## REPORT TO MARR AREA COMMITTEE – 27 MARCH 2018

### A96 ABERDEEN TO INVERNESS DUALLING POSITION STATEMENT

Figure 1: Indicative Alignments for A96 Eastern Section Dualling Options B, C and D

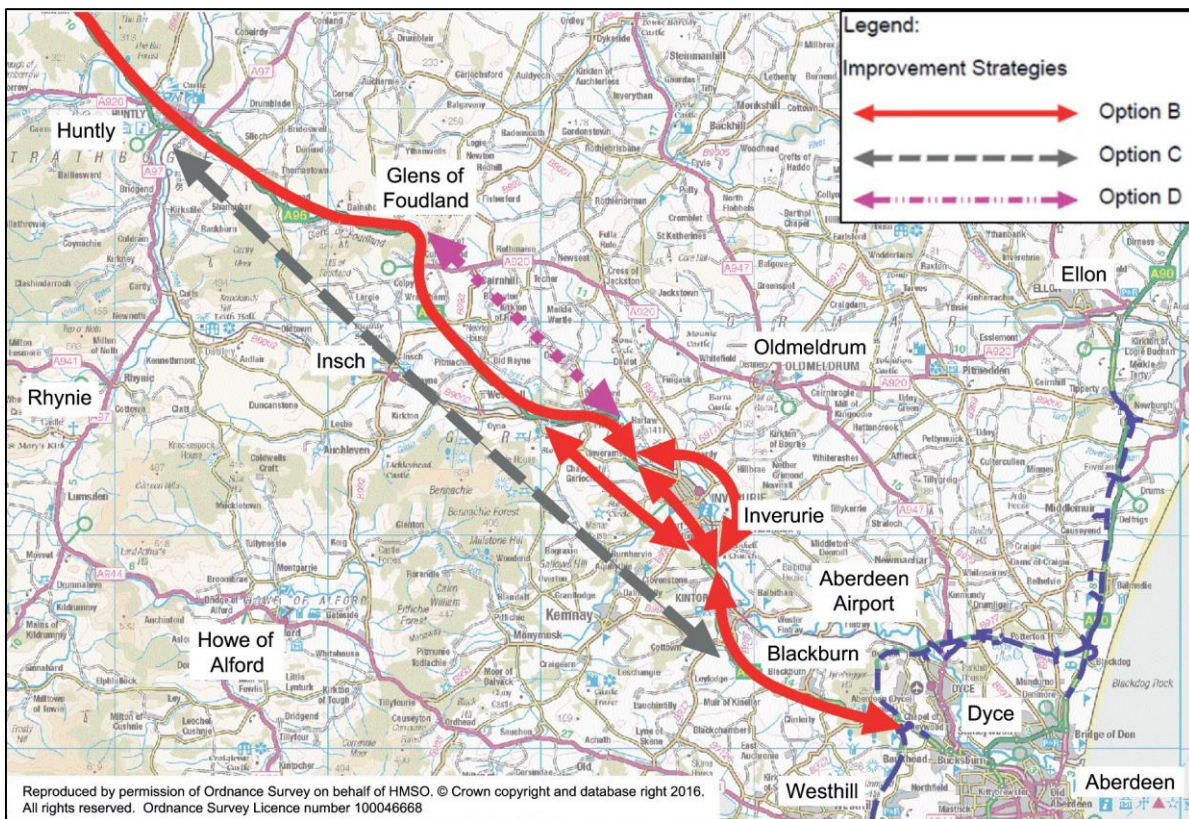
- 1) Option B: Existing A96 Corridor with offline bypasses - the principle of this option is an upgrade generally located along the route of the

existing A96 corridor, with the exception of offline bypasses of settlements along the existing A96. Under consideration are three potential strategies for bypassing Inverurie, comprising an upgrade to the existing Inverurie bypass and offline bypasses to the north or south of the town;

- 2) Option C: Offline from Huntly to Blackburn - this option was developed, irrespective of constraints, to provide a more direct line from Huntly to Blackburn, bypassing Inverurie to the south and avoiding a number of sections of poor road alignment on the existing A96; and
- 3) Option D: Offline from Glens of Foudland to north-west of Inverurie - this option was developed to provide a more direct line between a section of the A96 between the Glens of Foudland and north-west of Inverurie.

Figure 2: Indicative Alignments for Various A96 Eastern Section Options Pre-Sifting

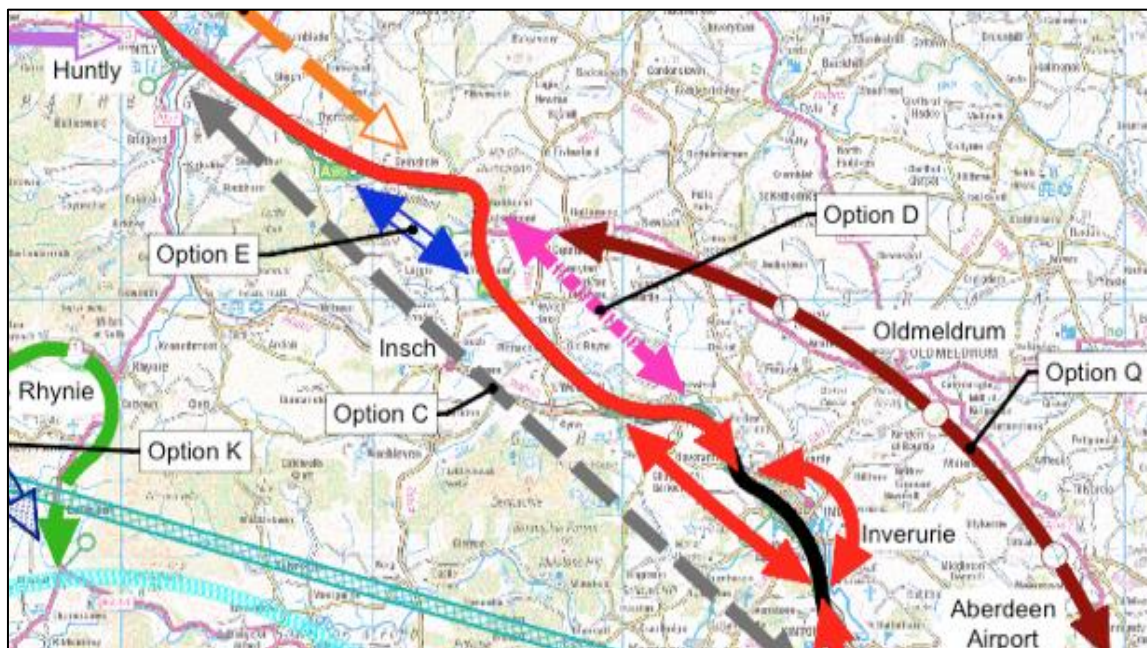
2.5.5 The initial consideration of corridors included an Option Q, which would see a new section of road constructed to the north and east of the existing A96 between Glens of Foudland and Dyce, bypassing Inverurie, Blackburn and Aberdeen International Airport, and linking with the A947 north of Dyce, but this option was ruled out during pre-assessment sifting stages. It is the view of Council officers, however, that this option was ruled out prematurely and that it may have certain advantages that have perhaps been overlooked during the assessment process:

- 1) It would alleviate concerns about the effects of the project on the iconic and protected landscape around Bennachie and the Keith Hall House and Gardens Designated Landscape;

- 2) It could aid economic development opportunities associated with enhanced access to the strategic road network for communities and businesses to the north and north-east of the current A96 and A947 road corridors;

- 3) It could facilitate the future development of Inverurie as much of the future growth planned for the town is to the east and south of the settlement;

- 4) It could relieve traffic pressure in Inverurie by enabling businesses in the Oldmeldrum catchment area and beyond to access the trunk road network without having to pass through Inverurie, which would not be the case if the new road went to the west of Inverurie;

- 5) It could potentially relieve traffic pressure on the A947, improving safety and reducing journey times between Oldmeldrum and Aberdeen;
- 6) Although further from Inverurie than other options, it would improve access to the A96 and the wider strategic road network for other population centres in Aberdeenshire and Aberdeen City such as Newmachar, Oldmeldrum, Dyce and Bridge of Don;

- 7) Although the trunk road would be further from Kintore Station it would be closer to Dyce Station;
- 8) It provides an opportunity to develop other interchange locations such as the potential reopened railway line from Dyce to Ellon and beyond and an interchange between Inverurie and Oldmeldrum;
- 9) It affords the opportunity to enhance active and sustainable transport provision along the current A96 for the benefit of residents of Blackburn, Kintore, Port Elphinstone and Inverurie; and
- 10) There may be different permutations of this option, such as re-joining the existing A96 somewhere west of Dyce, which provide additional or alternative benefits.

2.5.6 These concerns were raised with Transport Scotland, who subsequently confirmed that all feedback, including feedback received following completion of the DMRB Stage 1 assessment, continues to inform the option assessment process and that Aberdeenshire Council's observations with respect to the A947 and Option Q will be considered with all other feedback received as route corridor options are developed for assessment in the coming period.
